Memorandum to the City of Markham Committee of Adjustment February 26, 2025

File:	A/145/24
Address:	57 Montrose Crescent, Markham
Agent:	MGL & Co. Inc. (Maggie Low)
Hearing Date:	Wednesday, March 5, 2025

as it relates to a rear sunroom addition.

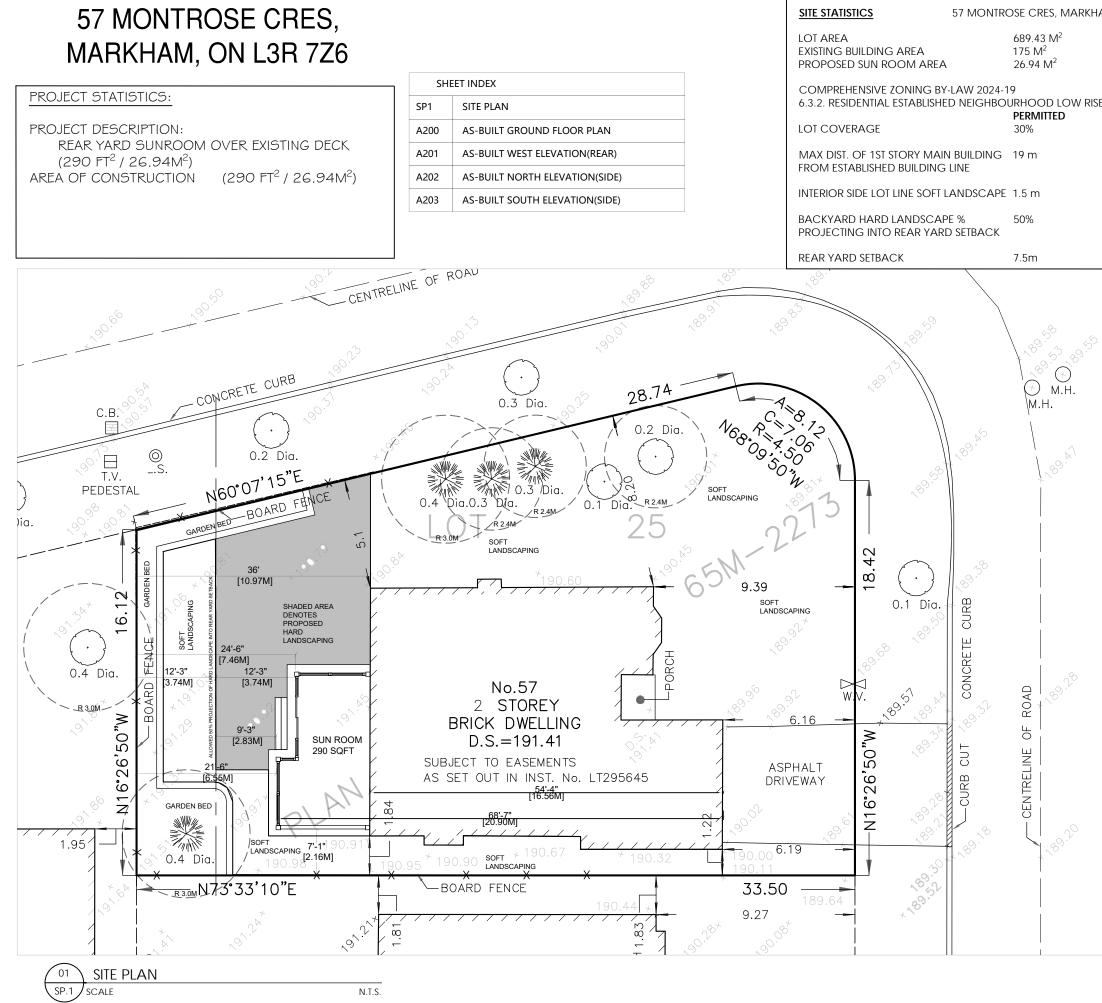
The Applicant is requesting relief to permit a minimum rear yard setback of 6.55 m (21.49 ft), whereas the By-law requires a minimum rear yard setback of 7.55 m (24.77 ft). This represents a reduction of approximately 1.0 m (3.28 ft).

This variance is entirely attributable to a small (southerly) portion of the existing rear yard sunroom. A significant portion of the sunroom is setback 7.46 m (24.48 ft) from the rear property line, which Staff considers as a minor deviation from what the By-law permits. Furthermore, given that the sunroom addition does not span the entire width of the existing dwelling, Staff are of the opinion that the requested variance will not have a marked impact to adjacent properties and is minor in nature.

The Applicant is requesting a maximum distance of the main building from the established building line of 20.90 m (68.57 ft) for the first storey whereas the Bylaw permits a maximum distance of 19.0 m (62.34 ft). This represents an increase of 1.90 m (6.23 ft) for the first storey.

The intent of this By-law provision is to regulate the building depth and massing in relation to the neighbouring lots. As previously noted, the relatively modest-sized sunroom addition does not span the entire width of the existing dwelling. The one-storey addition is also setback sufficiently from the streetline, resulting in minimal impacts on neighbouring homes or the streetscape. Staff are satisfied that sufficient setbacks and rear yard amenity space are provided and maintained to mitigate any potential impacts that the proposed building depth and massing may have on adjacent lots and the streetscape.

- 6. That the existing hardscaping be removed and that soft landscaping is restored as per the site plan submitted to the Committee of Adjustment dated January 24, 2025.
